UNITED STATES PATENT AND TRADEMARK OFFICE

APPLICATION NO.	FILING DATE	FIRST NAMED INVENTOR	ATTORNEY DOCKET NO.	CONFIRMATION NO.
10/825,817	04/16/2004	Robert W. Roldan	2003P14527US	8690

Office Action Summary

DETAILED ACTION

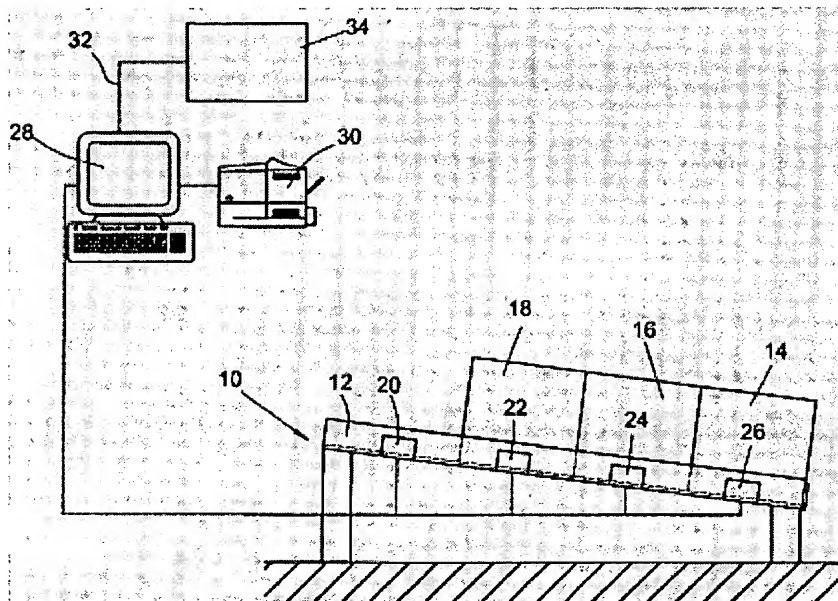
- (a) positioning manufacturing pieces on a gravity feed rack (components in bin elements 18, 16, 14);
- (b) sensing a removal of the manufacturing pieces (elements 20, 24, 26); and
- (c) electronically notifying in response to (b) (Abstract).

Referring to claim 2, Wilbert teaches the method and system of Claim 1 wherein (a) comprises positioning a plurality of kanbans (elements 18, 16, 14) each having a plurality of manufacturing pieces and wherein (b) comprises sensing removal of a kanban (Abstract).

Referring to claim 3, Wilbert teaches the method of Claim 1 wherein (b) comprises sensing when a position along the gravity feed rack is free of manufacturing pieces (Abstract and element 20).

Referring to claim 10, Wilbert teaches the method of Claim 1 wherein (a) comprises positioning a plurality of the manufacturing pieces to sequentially feed to a lower position on the

gravity feed rack (See figure above) and wherein (b) comprises sensing at a position higher than the lower position on the gravity feed rack (See figure above, for example, sensor 24 is at a higher position than sensor 26).

Referring to claims 13, Wilbert teaches a system of Claim 11, wherein the sensor is positioned to sense at a location along the gravity feed rack such that the lack of the manufacturing piece is sensed while another manufacturing piece is present below the location (See the figure).

Referring to claims 11, 17, and 20, Wilbert shows a gravity feed rack with sensors adjacent thereto (see the figure above). Wilbert clearly teaches the computer 28 generates a replenishment notification signal in response to a sensor detecting a drop in the number of supply
